Willoughby City Council Western Harbour Tunnel and Warringah Freeway Upgrade Submission to Transport for NSW

Willoughby City Council EIS Submission - Western Harbour Tunnel and Warringah Freeway Upgrade Project

Figure 2: Proposed reconfiguration of the Freeway between Sydney Harbour Bridge and Sydney Harbour Tunnel and Gore Hill Freeway (Source: EIS Chapter 5 Project Description page 5-36)

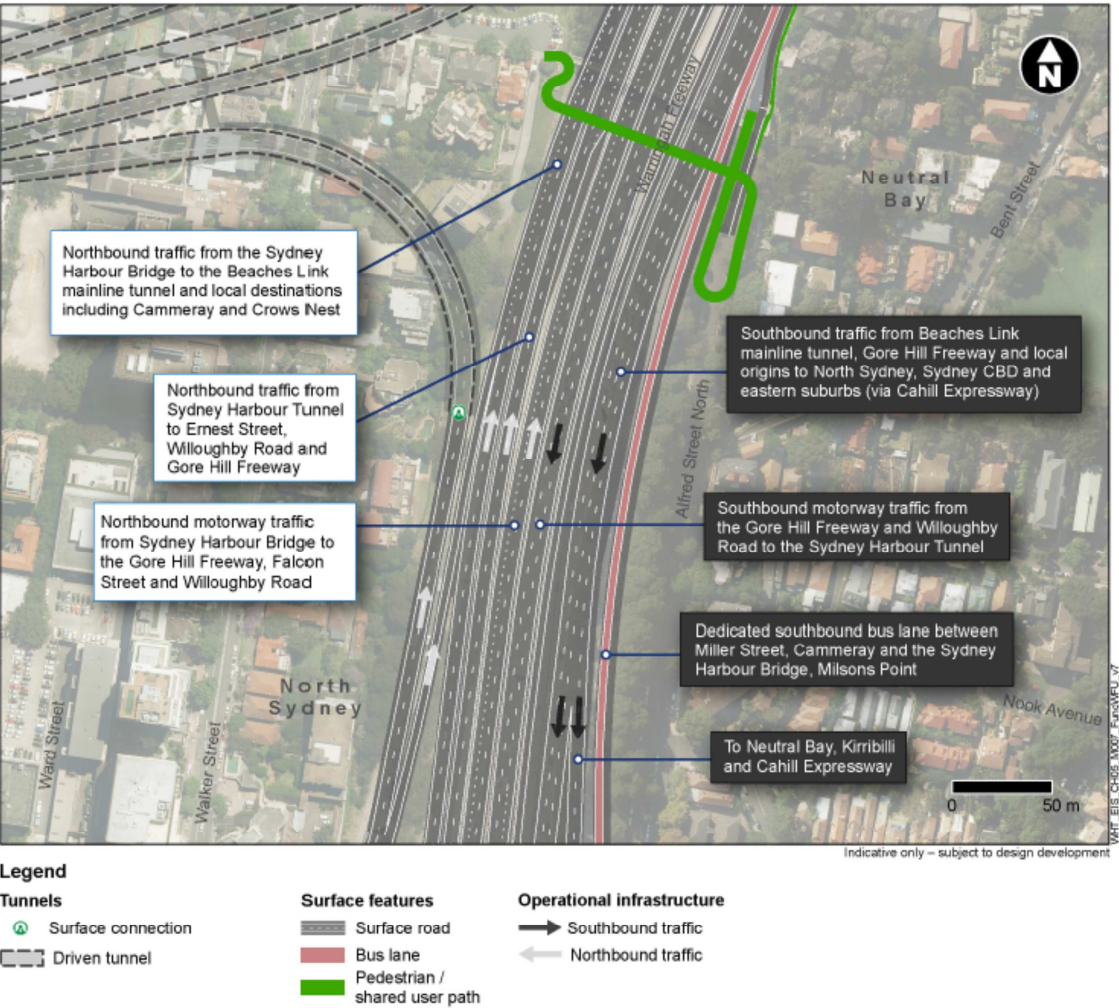
The on-going use of the Sydney Harbour Bridge by heavy vehicles is of a concern and it is questioned where the vehicles are coming/ going to.

The extreme change and worsening in performance is difficult to understand and accept given that the performance now (in 2020) is acceptable. It would be appropriate to request further explanation of the model design and operation and its results. Could it be that one movement is leading to all the problems and the rest of the intersection operates satisfactorily?

Proposed change to the Urban National Land Transport Network (Road) in Sydney

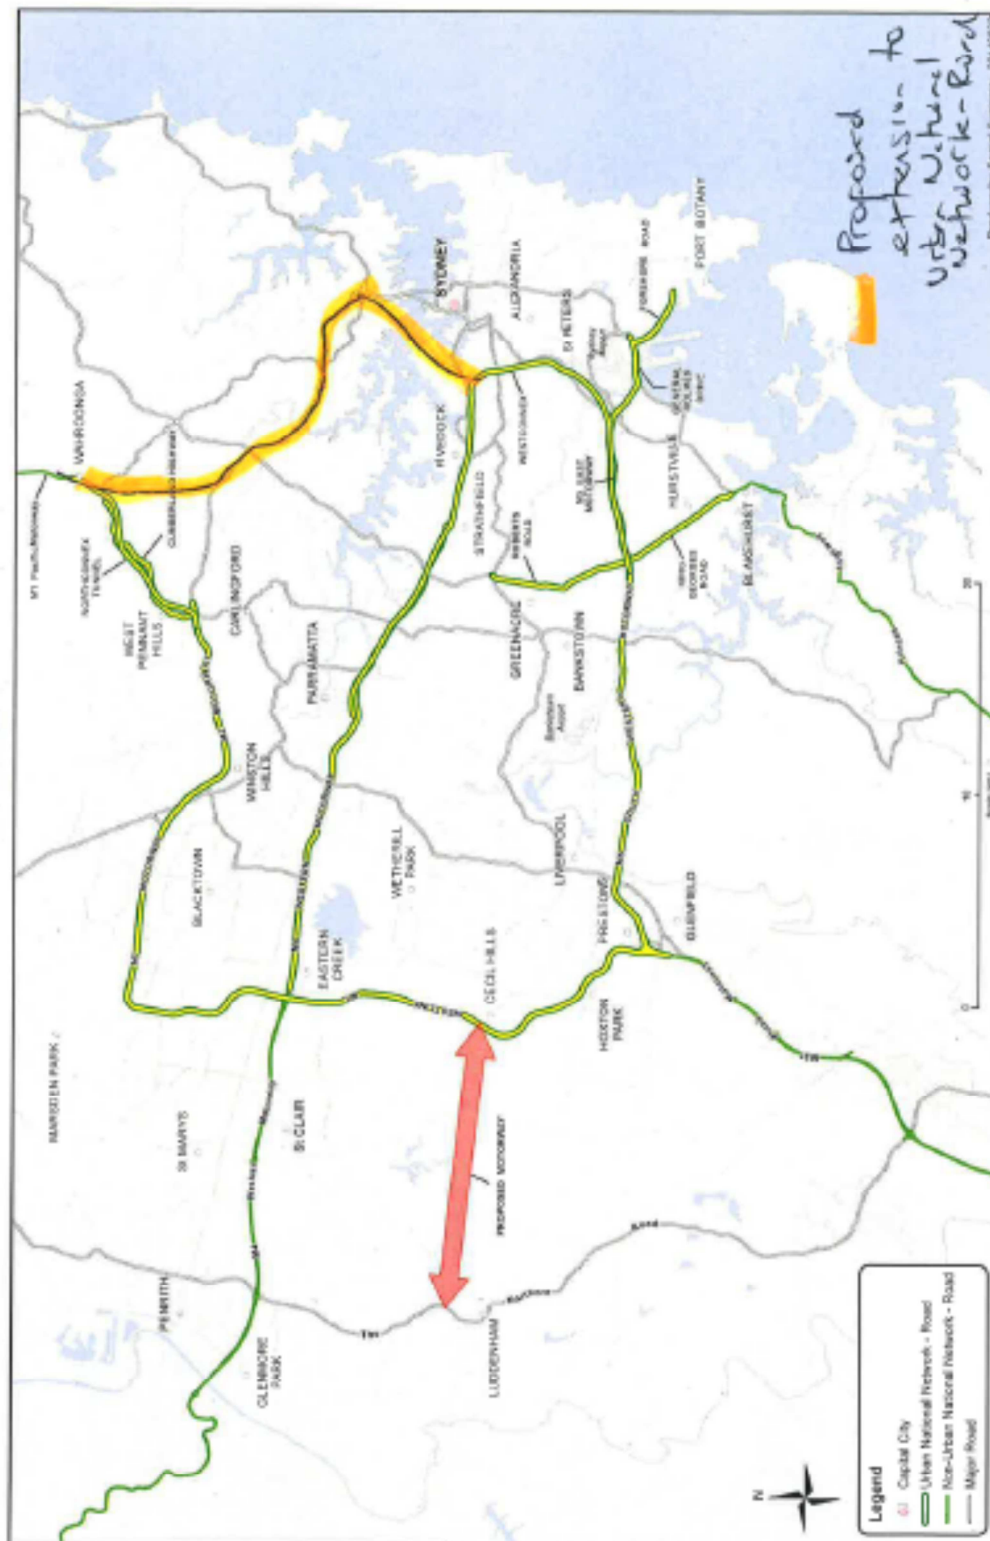
Route No. 1 traverses around Australia and is recognised as the primary route serving the whole of Australia. It is provided on the most direct and highest standard route. The Tunnel in combination with WestConnex, Lane Cove Tunnel, M2 Motorway and NorthConnex could be renumbered as route number 1. This would provide a continuous motorway standard route between Pacific Motorway M1 and Princes Highway A1. The future M6 Stage 1 could also lead to the extension of route number 1 as motorway standard.

Warrinich Freeway - east of Miller St.

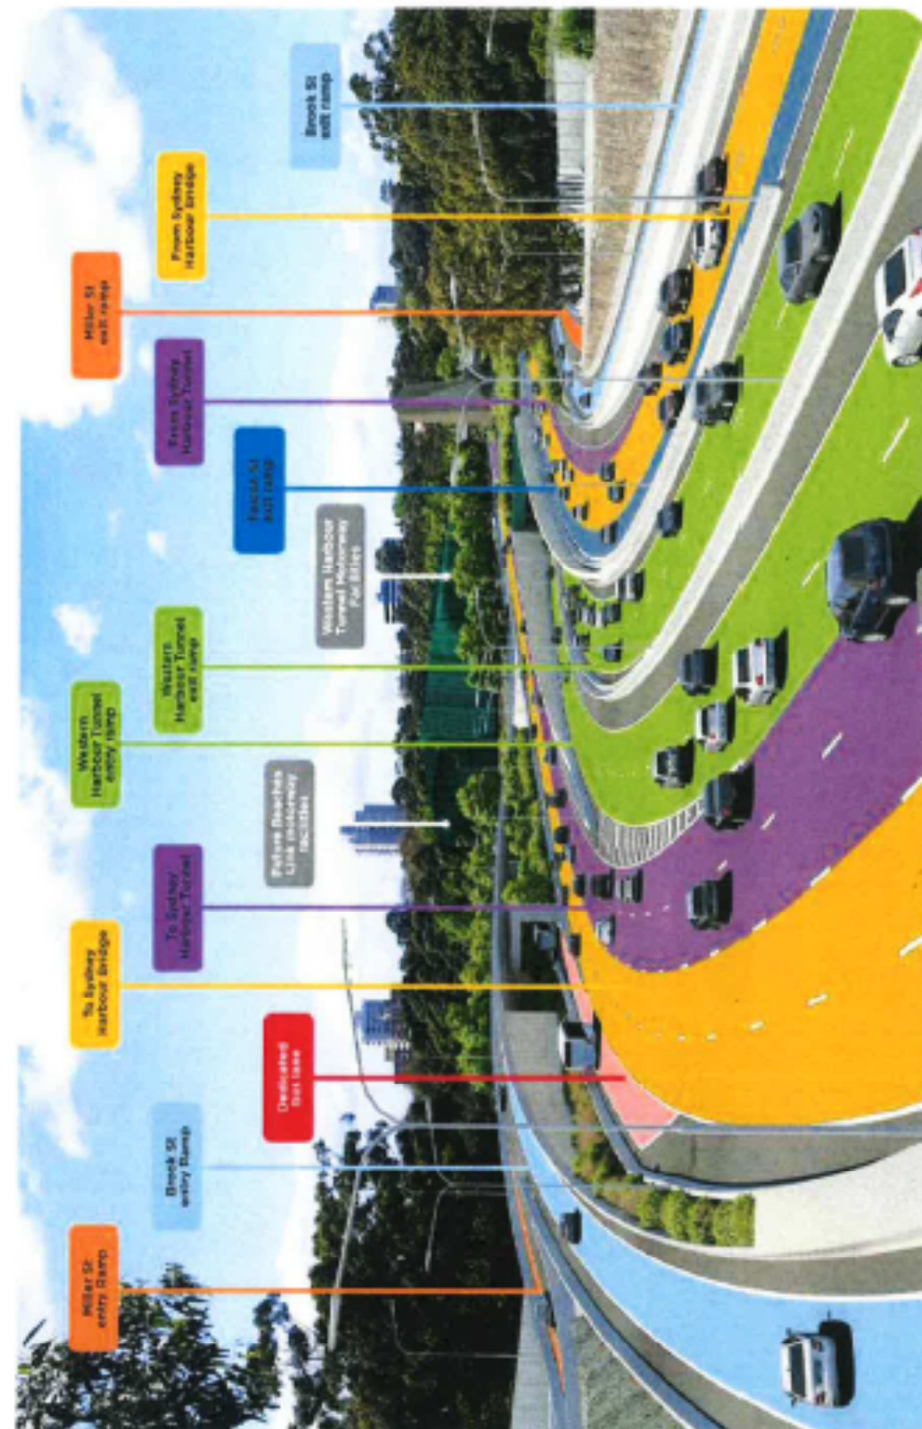
In view of the successful existing traffic configuration, with Sydney Harbour Tunnel traffic having the option of using both Miller and Brook St ramps, it is difficult to appreciate either the reasons for, or the benefits of, the proposed reconfiguration and we request that this aspect of the planning be abandoned in favour of the existing ramp entries and exits. To shift a major portion of the Sydney Harbour Tunnel traffic onto Willoughby Rd will further overload an arterial road already acknowledged as operating at full capacity in peak hours.
